CHANGE NOTICE

Effective Date: AUGUST 8, 2012
Log Number: CN-04-438
Subject: THERMOMETER LOCATION CHANGE
Model Affected: CMA-180

CMA-180 THERMOMETER BRACKET PN 17534.00

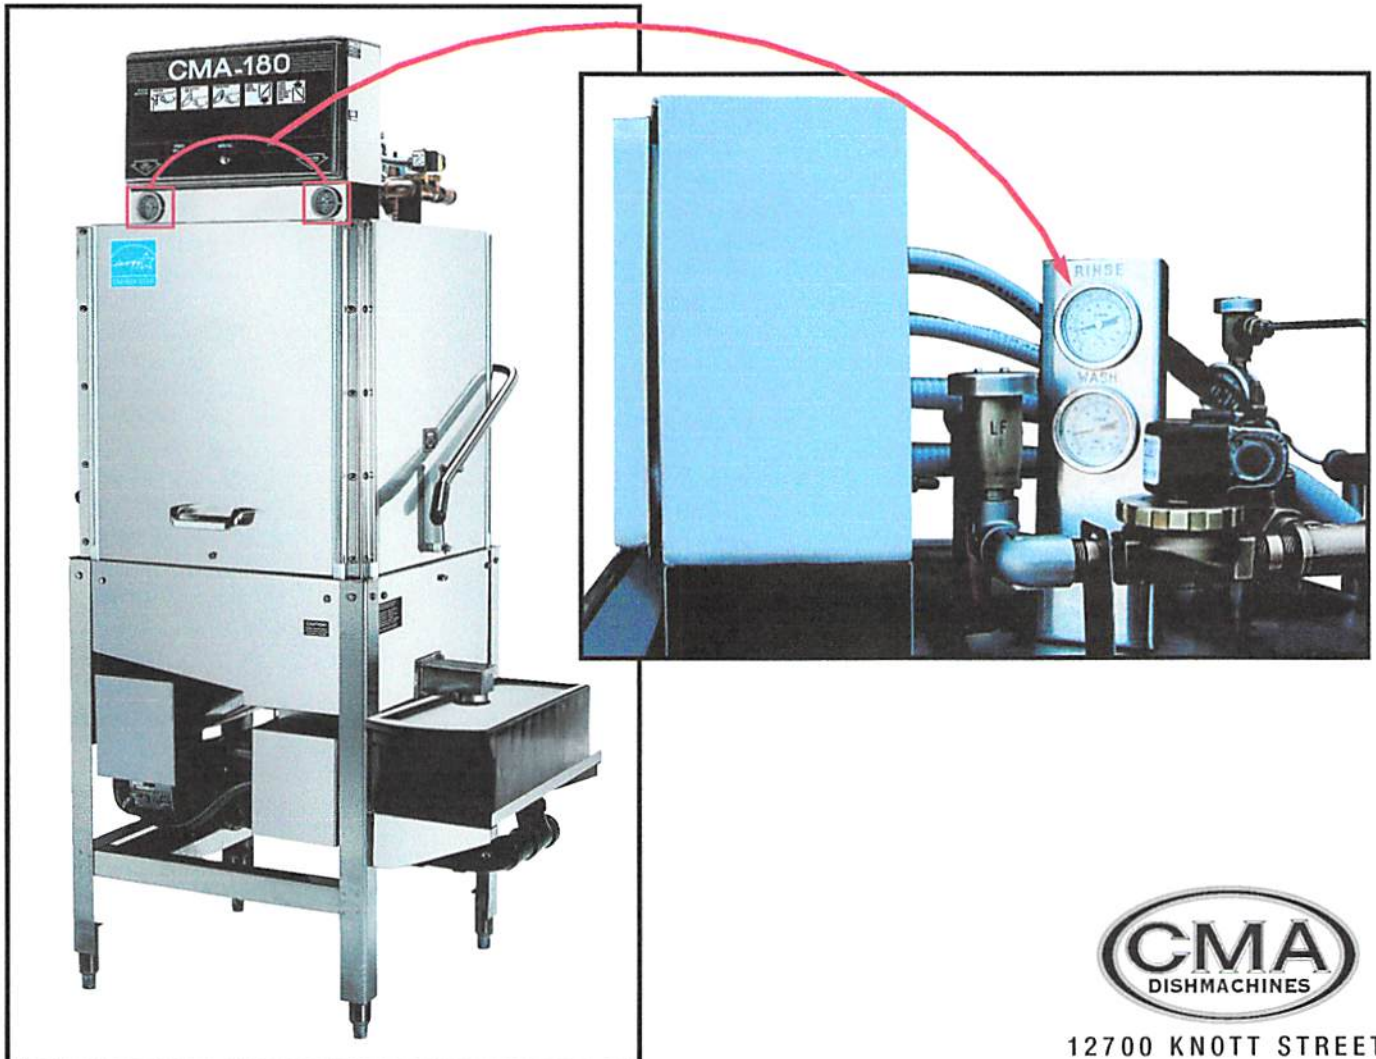
The thermometers for the CMA-180 have been removed from the control panel and relocated on its own "dual gauge bracket" set back away from the steam zone. The new location will reduce the moisture the thermometers will be subjected to, and provide easier access for service. The new thermometer bracket has been etched with the words "Rinse and Wash" to easily identify each of the thermometers.

The new thermometer bracket can be installed on existing machines in the field by securing to the top of the CMA-180 wrapper.
